# UNITED STATES PATENT AND TRADEMARK OFFICE

APPLICATION NO.	FILING DATE	FIRST NAMED INVENTOR	ATTORNEY DOCKET NO.	CONFIRMATION NO.
10/584,802	07/12/2006	Jon Erik Brennvall	06085	3412
23338 7590 03/10/2008 DENNISON, SCHULTZ & MACDONALD 1727 KING STREET SUITE 105 ALEXANDRIA, VA 22314				
EXAMINER DESAL, NAISHADH N				
ART UNIT 2834		PAPER NUMBER		
MAIL DATE 03/10/2008		DELIVERY MODE PAPER

# Office Action Summary

**DETAILED ACTION**

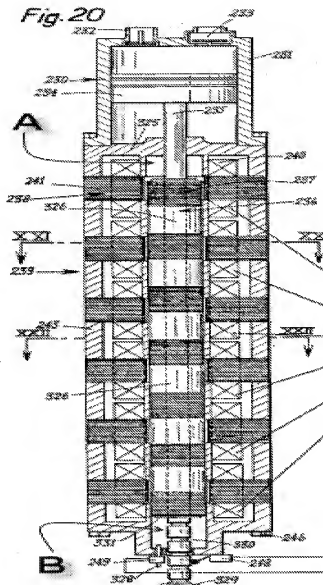
Machine with an electromechanical converter (abstract), with a linear movable piston (Fig 20,234) which is arranged in a tubular cylinder (Fig 20,231) to operate as a working

element in a motor or a generator (abstract) and which is provided with magnetic elements (abstract) which establish an outwardly directed electrical field of force (Col 17 ll 58-63), which is effective towards a surrounding row of tubular coils (Fig 20,240 and 241), where at each end of the cylinder is formed a gas spring which forms a resonance-effective arrangement (Fig 20, A and B below), and where the interaction between the magnetic fields of the coils (Fig 20,240) and the magnetic elements (Fig 20,237) respectively obtain energy transmission between the electrical energy in the coils and the mechanical energy of the axial movement of the piston (Fig 20,234) in the cylinder (Fig 20,231), characterized in

- that the cylinder (Fig 20,231) is closed to form tight end chambers, so that there at each end of the piston there is formed a gas spring of high pressure (chamber area above and below piston in Fig 20,234),
- that the piston supports a row of centrally placed tubular permanent magnets (Fig 20,237)) or alternative coils (Fig 20,240), and
- that the cylinder (Fig 20,231) comprises a row of coordinated coils (Fig 20,240) or alternative permanent magnets for increasing the machine's piston area and/or the piston's length of stroke.

Machine according to claim 1, characterized in that the piston (Fig 20,234) comprises a concentric row of tubular magnetic elements (Fig 20,237) which are placed with a mutual intermediate gap (Fig 21,242), and that in these gaps are arranged tubular coil arrangements with coils (Fig 20,240) for increasing the area of the piston.

Machine according to claim 2, characterized in that the piston (Fig 20,234), is at least on one end, connected to a piston bar (Fig 20,235), said piston bar is guided out through an end chamber for transferring the mechanical energy to or from the machine (Fig 20 shows that the piston bar is guided through an end chamber to transfer mechanical energy to or from the machine).

Machine according to claim 2, characterized in that the pressure inside the casing at each side of the piston (Fig 20,234) in the end chambers (Fig 20, A and B) is over 10, preferably over 30 bar.

(Fig 20 clearly shows that the pressure inside the piston chambers (above and below the piston) are controllable by the valves (elements 232 and 233). It would have been obvious to a person having ordinary skills in the art to modify and adjust the pressure inside the chambers to match the specific needs).
